ELIZABETH MINE SUPERFUND SITE

**Value Engineering Study
For
U.S. Environmental Protection Agency
Region 1, Boston, MA**

Study Date: June 10 - 12, 2008

September 18, 2008

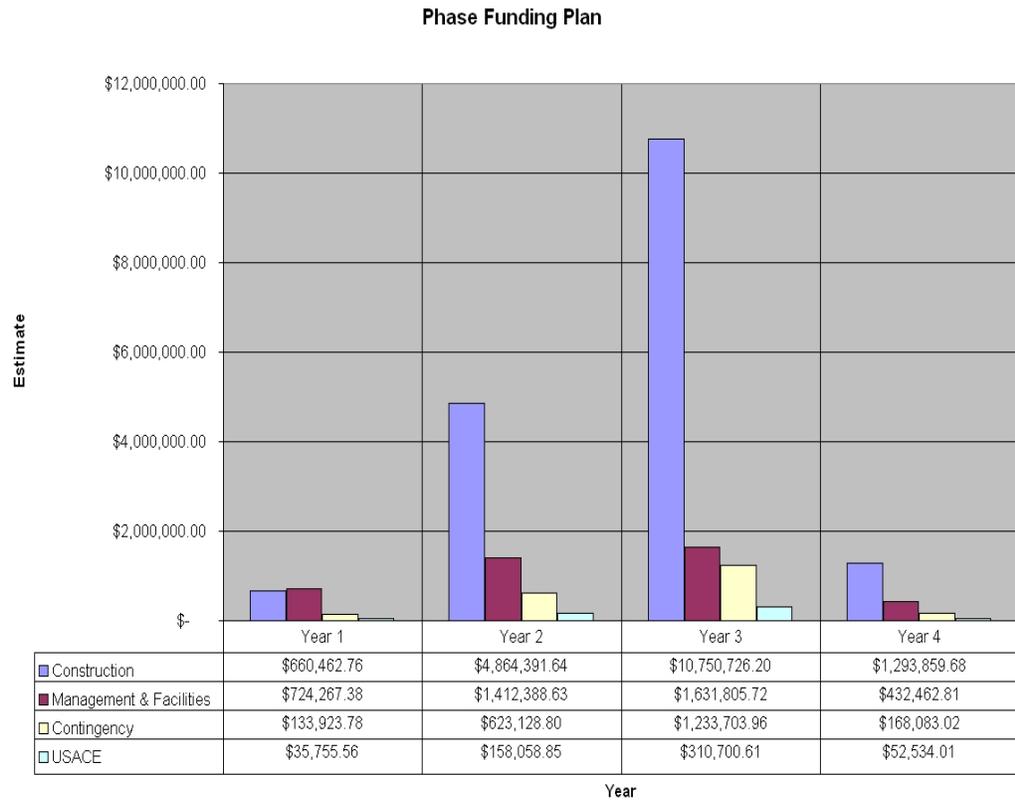
15 **REDO OR OPTIMIZE PROJECT CONSTRUCTION SCHEDULING.** The schedule developed to support the NTCRA phased funding plan for the Elizabeth Mine Superfund site is a classic S-Curve resource loaded; however, the construction/management cost ratio is unbalanced. The following is a graphical presentation identifying yearly funding requirements broken down into construction, management and facilities, contingency, and USACE costs:

As the graph depicts, the construction/management cost ratio in Year #1 is nearly 50/50 with very little construction placement. In fact, the only remedial action activities scheduled, other than work plan development, mobilization activities, and some E&S, is the Copperas Factories lead removal/containment work in accordance with NHPA direction. This task is anticipated to be a surgical and/or archeological removal type action the will be slow and laborious. Because the management and facility costs are a time dependent cost at an average of \$7,500/work day, as compared to a task dependent construction cost, it is suggested that a resource loaded network analysis schedule be developed to identify durations, calendar restrictions, such as winter shutdown, successor/predecessor relationships, any constraints and other budgetary information to assist in Earn-Value management during
